BOUNDARY & TOPOGRAPHIC SURVEY
DOMINICAN PARCEL A.P.N (015-163-03)
MARIN COUNTY
CITY OF SAN RAFAEL

TENTATIVE MAP, DOMINICAN VALLEY SUBDIVISION
DOMINICAN PARCEL A.P.N (015-163-03)
MARIN COUNTY, CALIFORNIA

PRELIMINARY GRADING PLAN
 DOMINICAN PARCEL A.P.N. (015-163-03)
 MARIN COUNTY, CALIFORNIA

<p>PRELIMINARY DRAINAGE PLAN</p> <p>DOMINICAN PARCEL A.P.N. (015-163-03)</p> <p>CITY OF SAN RAFAEL</p>	<p>OBERKAMPER & ASSOCIATES</p> <p>CIVIL ENGINEERS INC.</p> <p>7200 REDWOOD BLVD SUITE 305 SOVATO, CA 94945 PHONE: (415) 897-2800 WWW.OBERKAMPER.COM</p>
<p>Scale: 1" = 60'</p> <p>Drawn by: BM</p> <p>Field Crew: AS</p> <p>Checked by: LEO</p> <p>Date: 12/1/2023</p>	<p>SHEET</p> <p style="font-size: 2em; font-weight: bold;">C5</p> <p>5 OF 6</p> <p>22-192</p>

SHEET
C1
1 OF 6
22-192

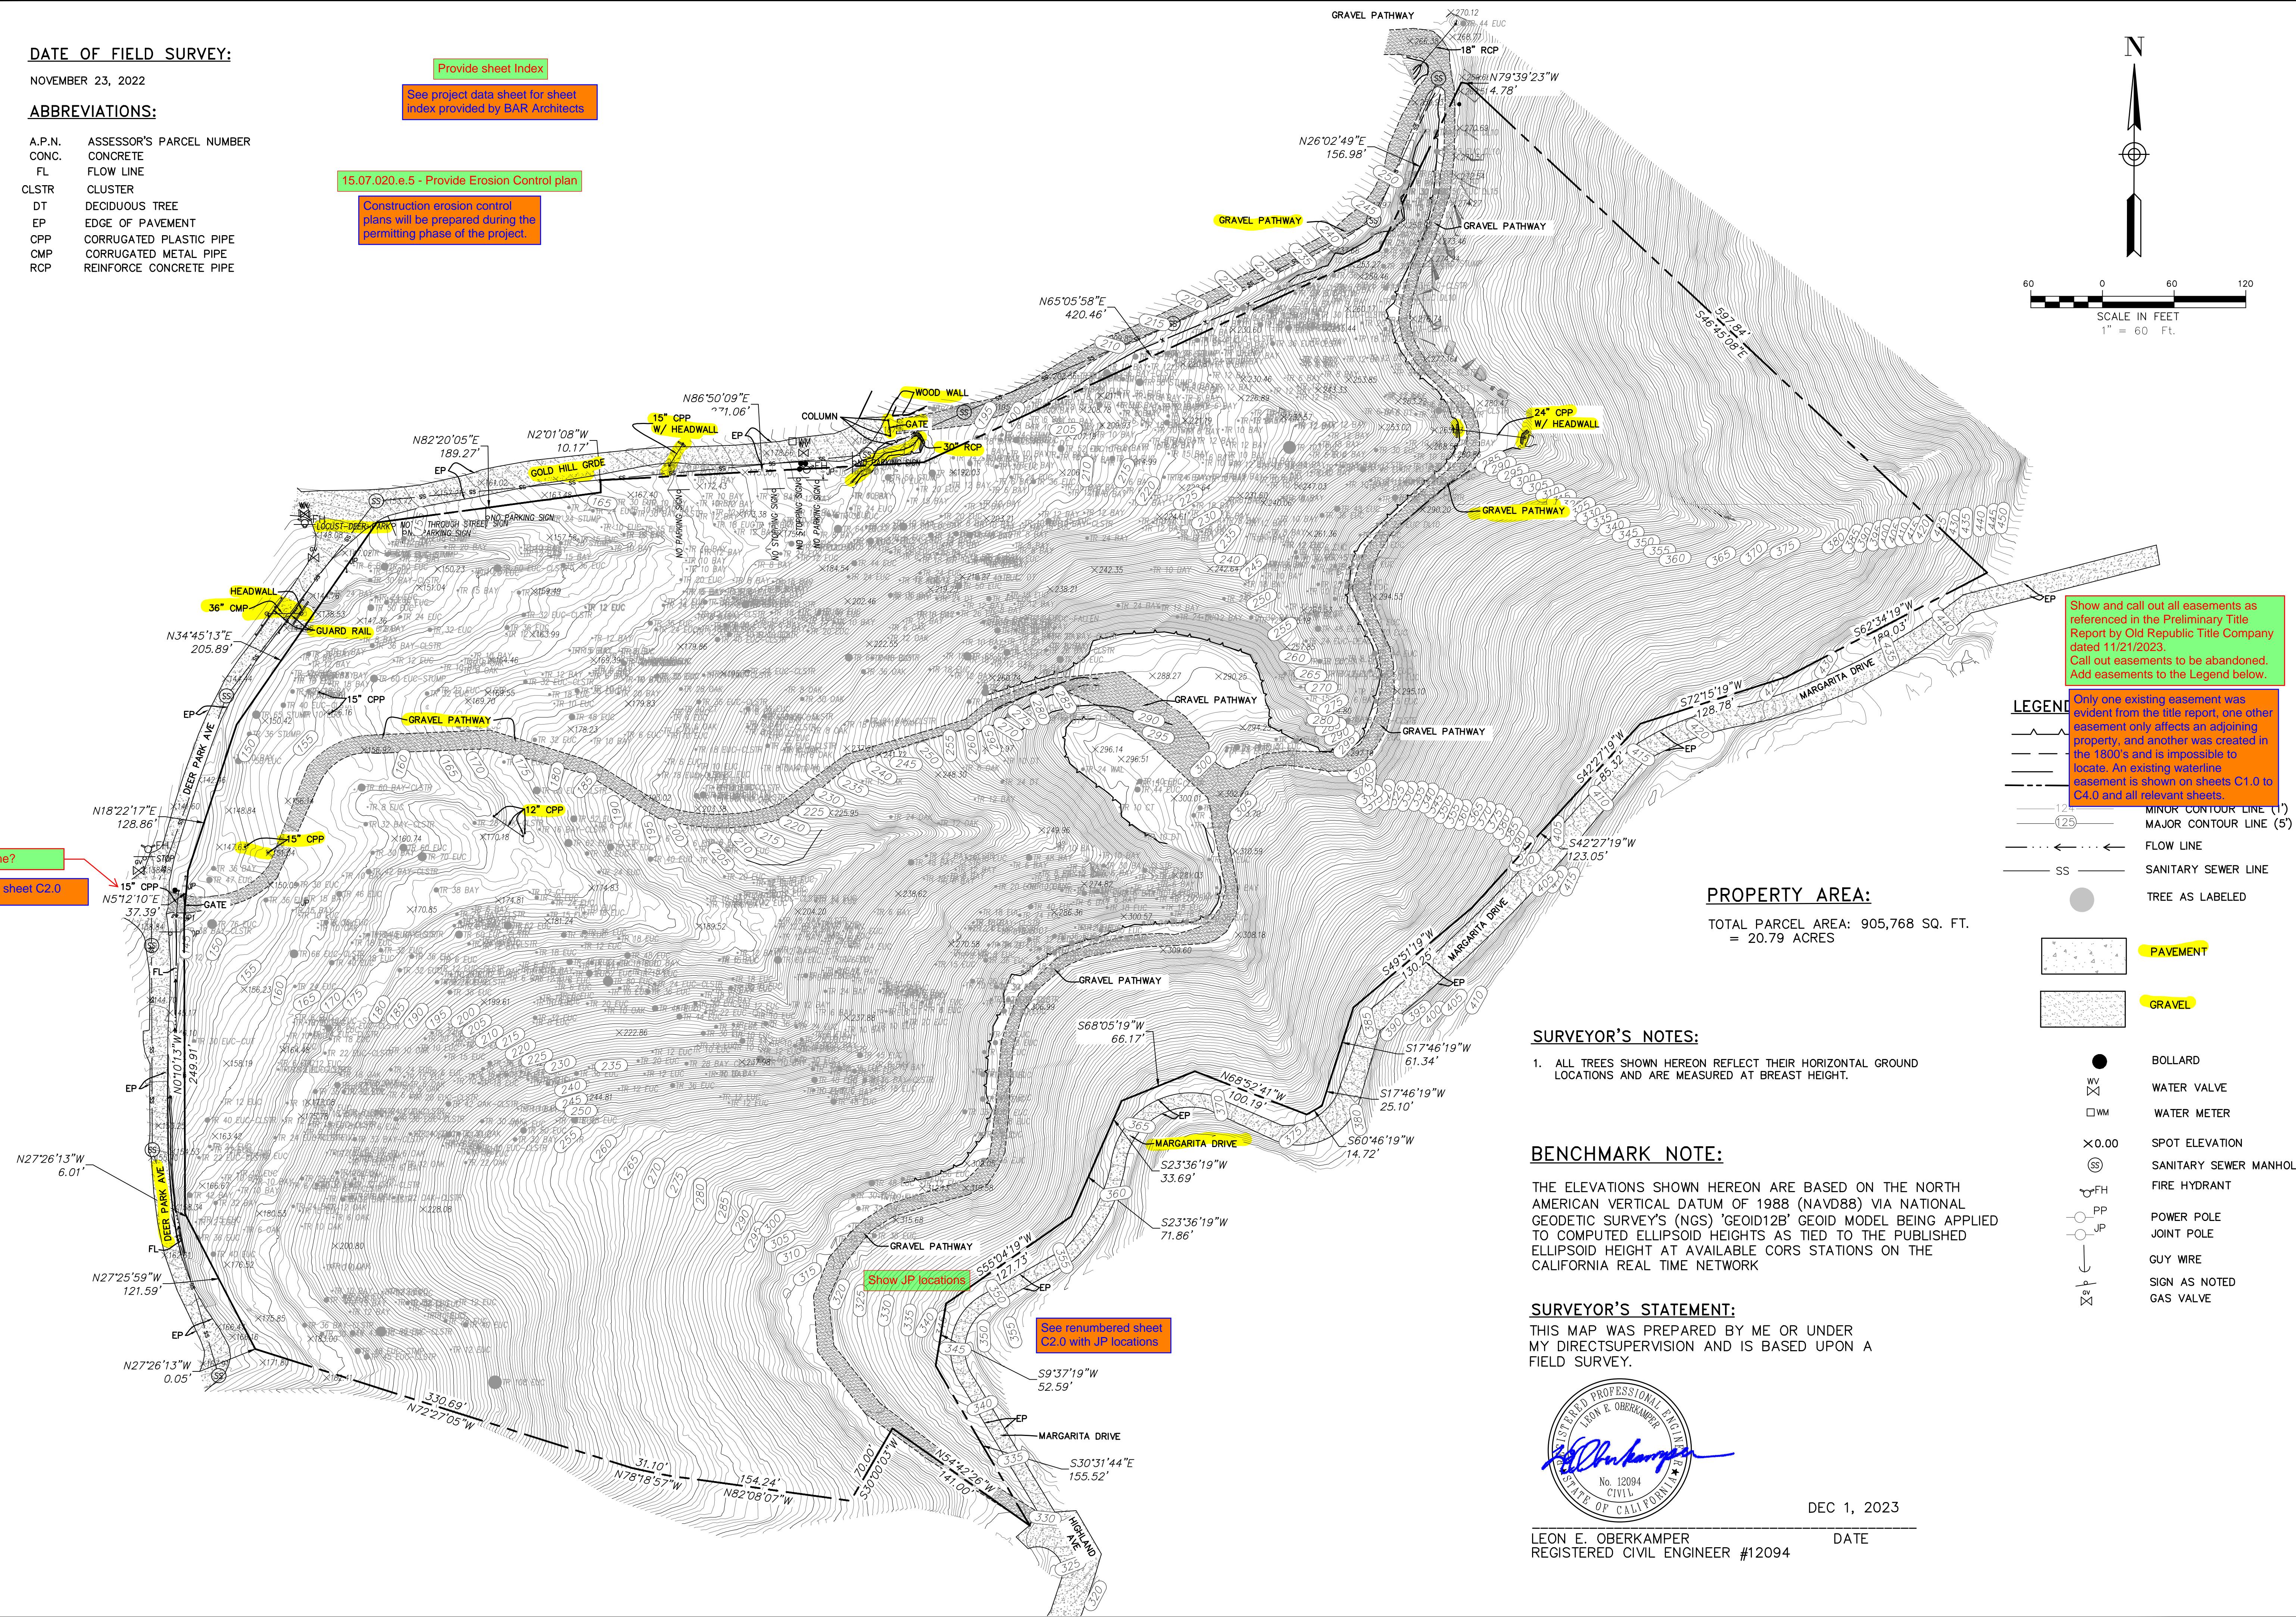
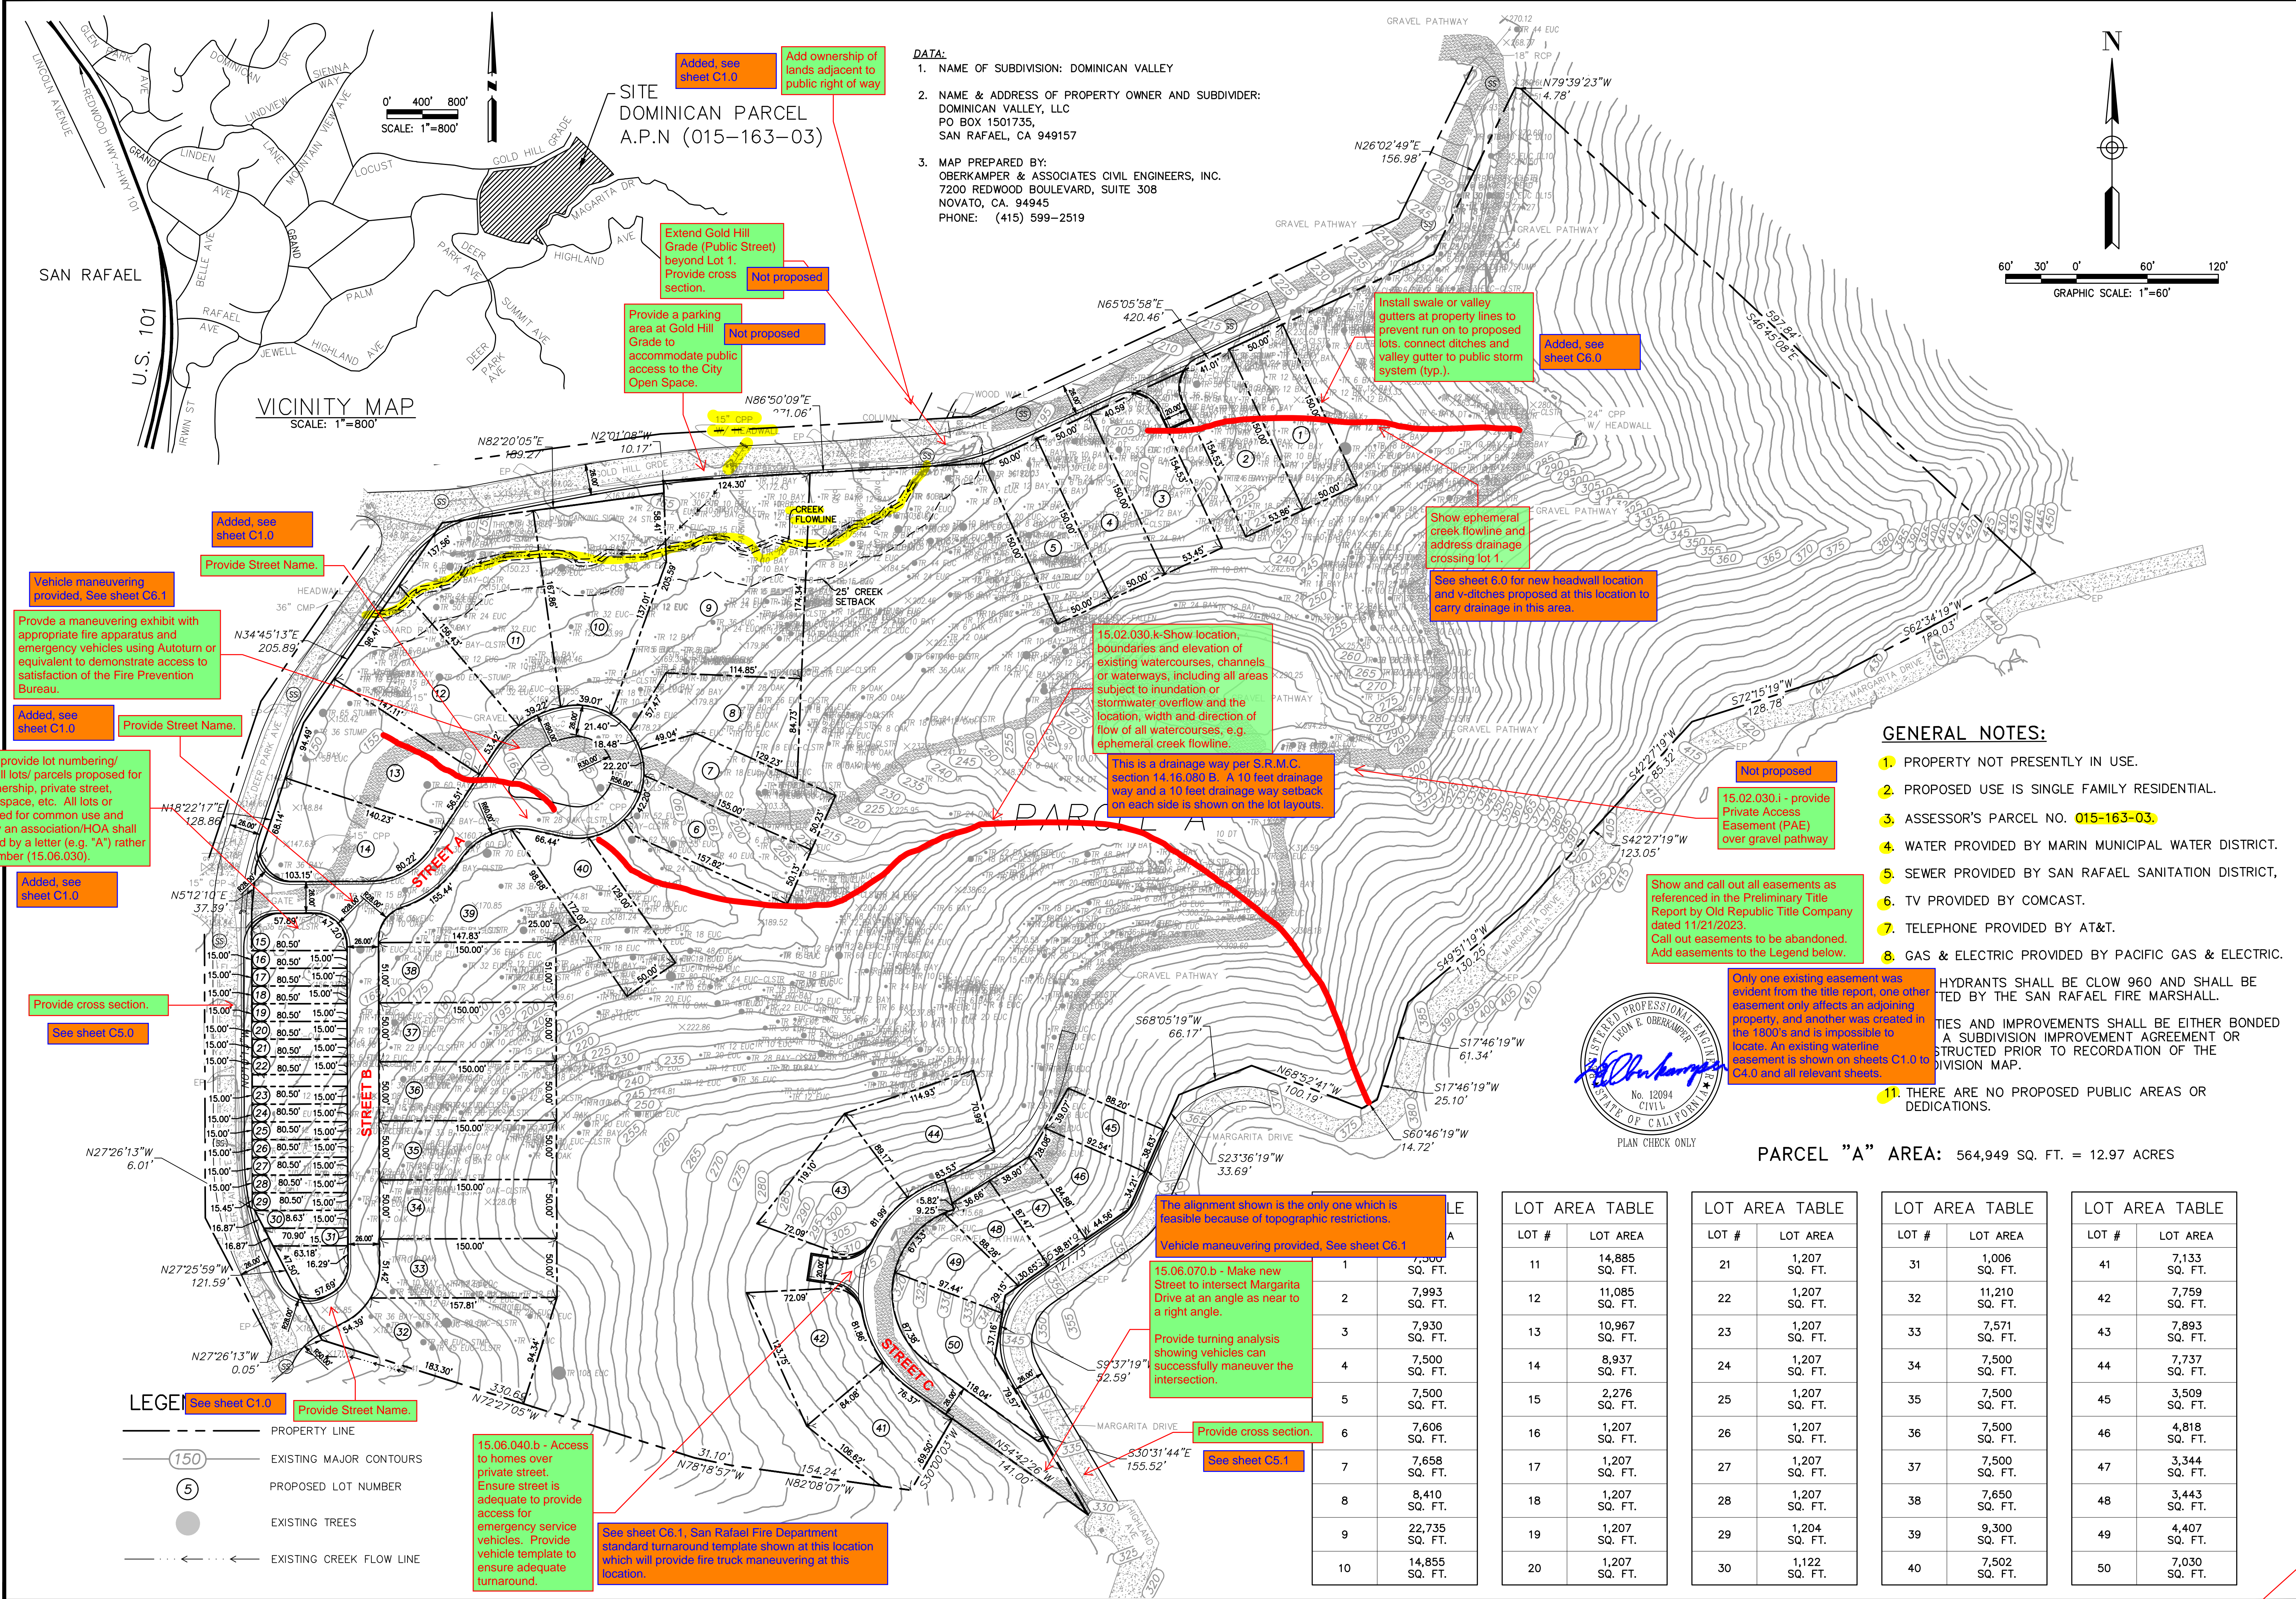
Provide sheet Index

Show and call out all easements as referenced in the Preliminary Title Report by Old Republic Title Company dated 11/21/2023. Call out easements to be abandoned. Add easements to the Legend below.

Street name?
See renumbered sheet C2.0

Show JP locations
See renumbered sheet C2.0 with JP locations

See project data sheet for sheet index provided by BAR Architects

Only one existing easement was evident from the title report, one other easement only affects an adjoining property, and another was created in the 1800's and is impossible to locate. An existing waterline easement is shown on sheets C1.0 to C4.0 and all relevant sheets.
